REQUEST FOR PLANNING COMMISSION ACTION

REQUEST FOR PLANNING COMMISSION ACTION

Item Name: PUBLIC HEARING - Variance - 343 Lakeview Terrace Boulevard

Meeting Date:		July 11, 2024				
Item Name:		Site Plan & Design Review - 219 Frontage Road East				
Originating Department:		Community Development				
Presented by:		Lane Braaten				
Previous Commission Action (if any):						
Item Type (X only one):	Consent		Regular Session	X	Discussion Session

GRADING, DRAINAGE
& PAVING PLAN

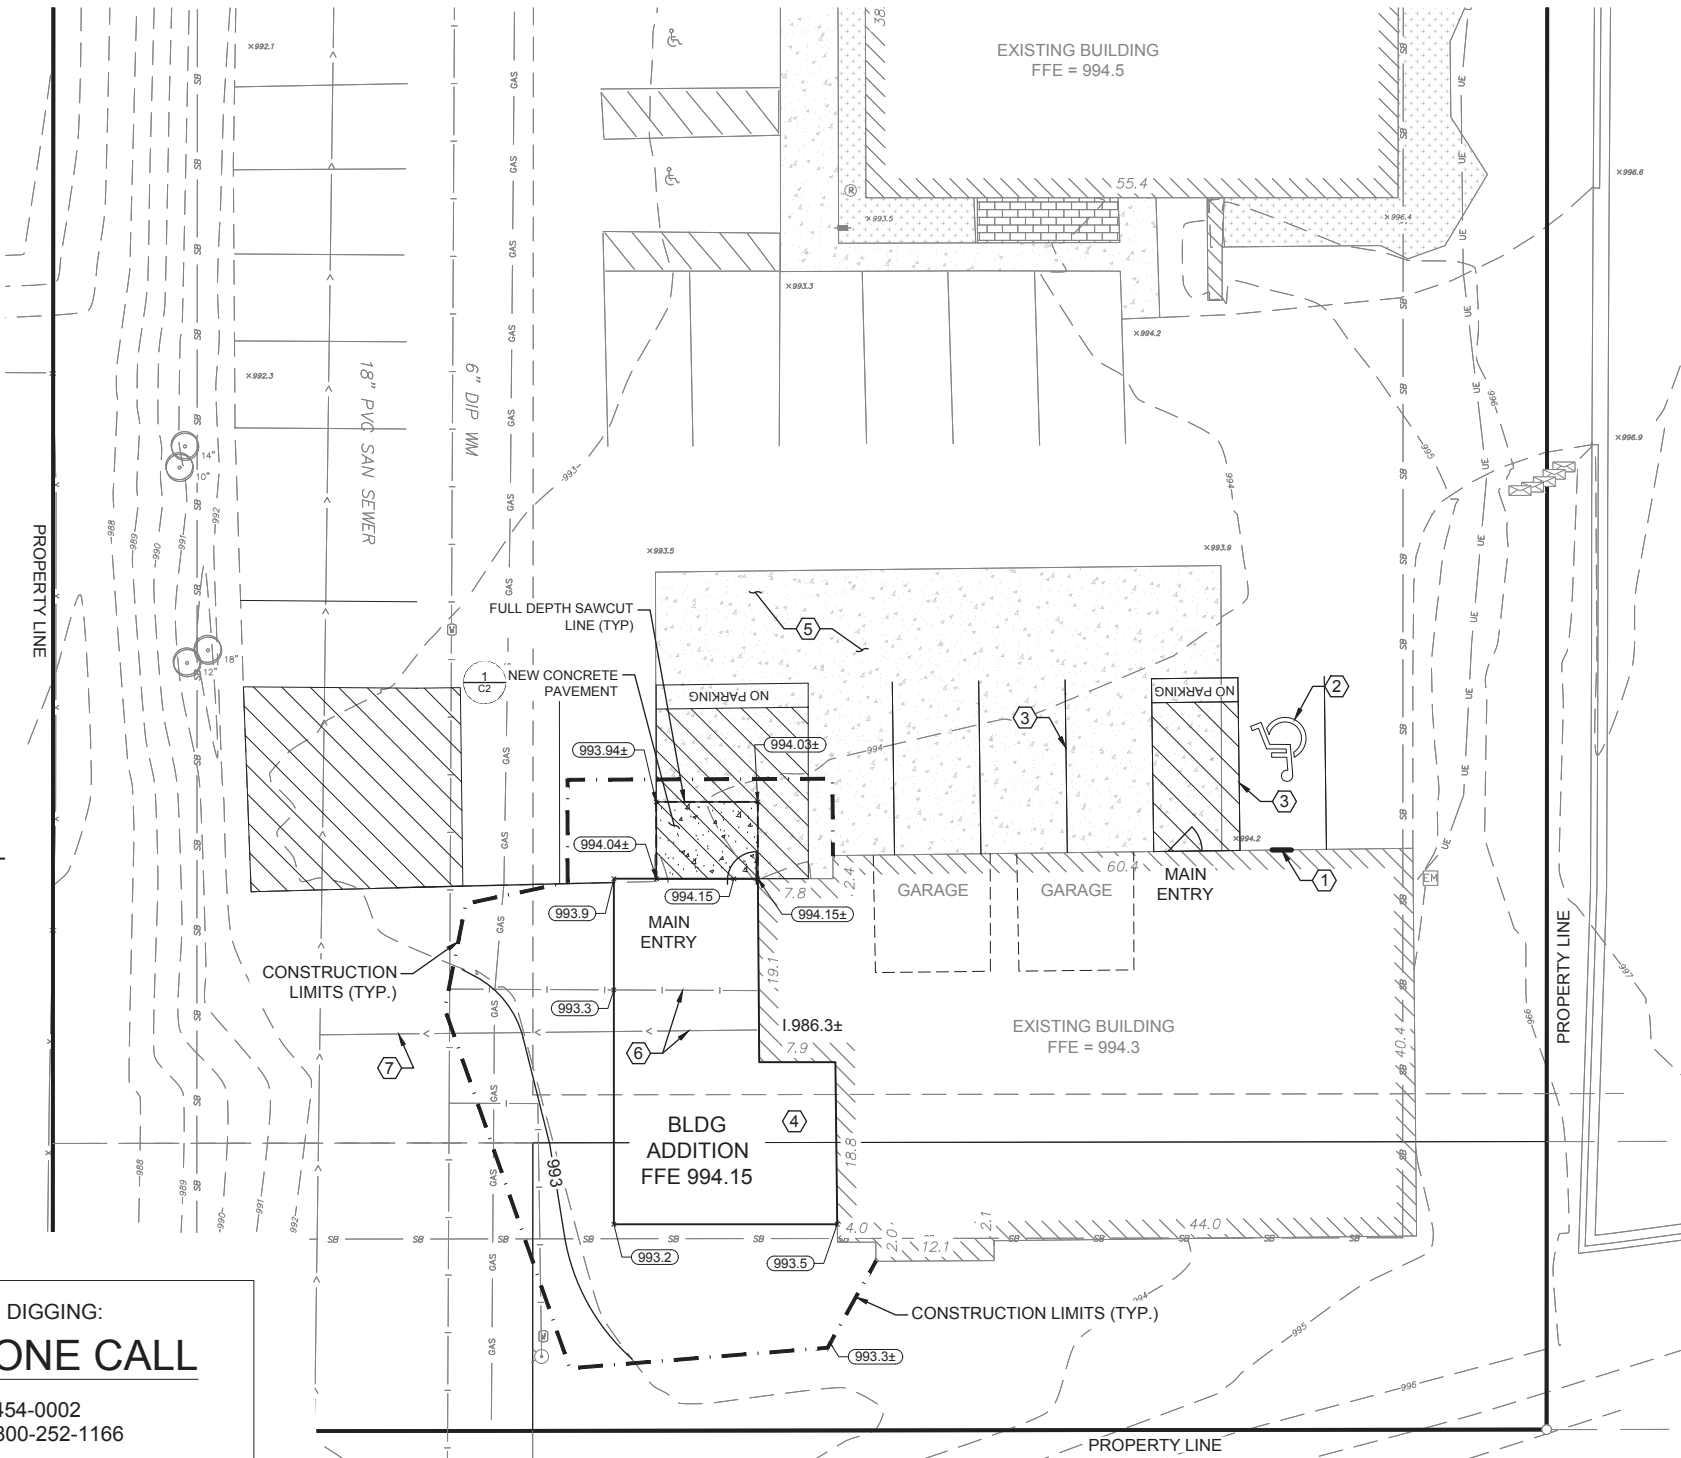
The City Engineer and Public Services Director have conducted an initial review of the grading, drainage and utilities. Any approval of the plan should include a condition requiring the applicant to work with the City Engineer to revise the utility and grading information to the satisfaction of the City prior to any work commencing on site.

3. The applicant shall work with the City Engineer and Public Services Director to revise the grading, drainage, and utility information to the satisfaction of the City prior to any work commencing on site.
